Our ref: CLIM3002_EIA

**Stocktons, 140 Great Ancoats Street (planning ref: 142535/FO/2025) – Environmental Impact Assessment
Supplementary Note**

Title	Noise Response to Manchester City Council's Comments		
Project	Stockton's, Manchester		
Reference	2835.NT.4.0	Author(s)	BHo
Date	22 July 2025	Reviewer	TF

Image 1: Space provision for suspended ceilings

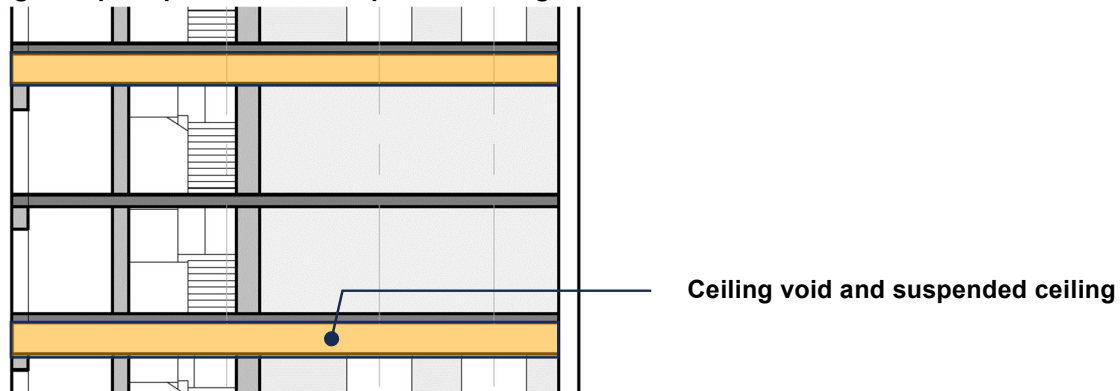
[EH comment] *The Noise and Vibration Sections have not given any details on this.*

2.4 The Gyms and Swimming Pool will require detailed acoustic design to control noise and vibration transmission to other parts of the development. Ceiling void space has been allowed for above and below the Gym/Swimming Pool on Level 19 and also above and below the Games Room on Level 31 of Building A:

Image 5: Diecast internal ground floor layout

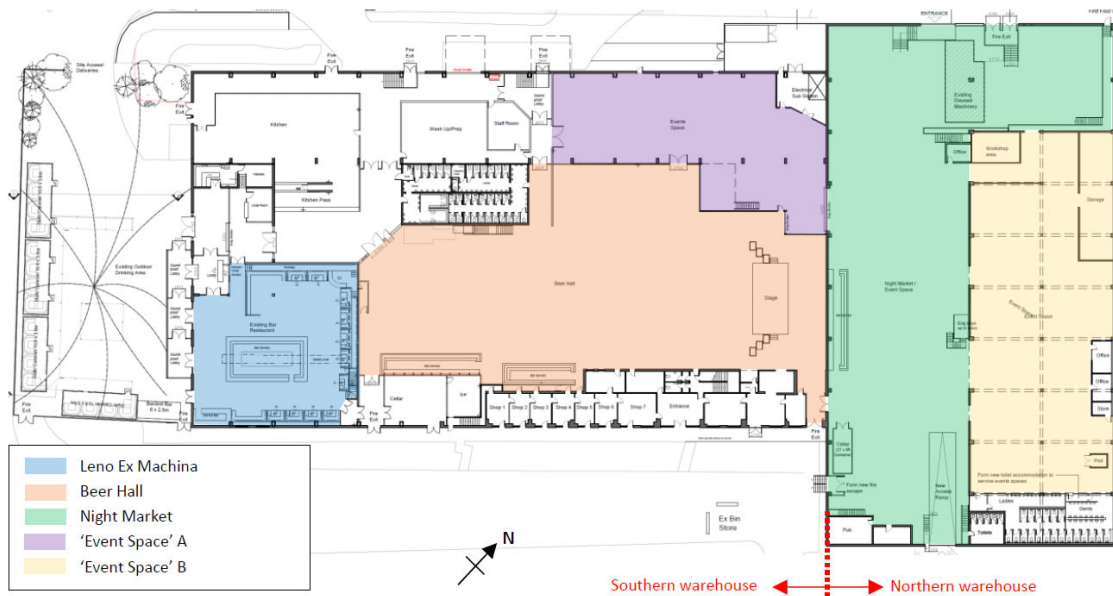
[EH comment] A noise survey was undertaken but consideration was not given to the entertainment venue Diecast as it was thought to be a temporary venue. Noise from Diecast should be considered as (planning application 142386/FO/2025) is for the permanent use of the building as an entertainment venue. Therefore, the baseline noise survey should be updated to reflect this. This may alter on the acoustic performance of the glazed elements to meet criteria.

3.7 The Stockton's warehouse, which would be demolished as part of the proposed scheme, shares a party wall with Event Space B and the Night market on the northeastern façade. Once demolished, the two proposed buildings would be close to this northeastern wall although not physically connected.
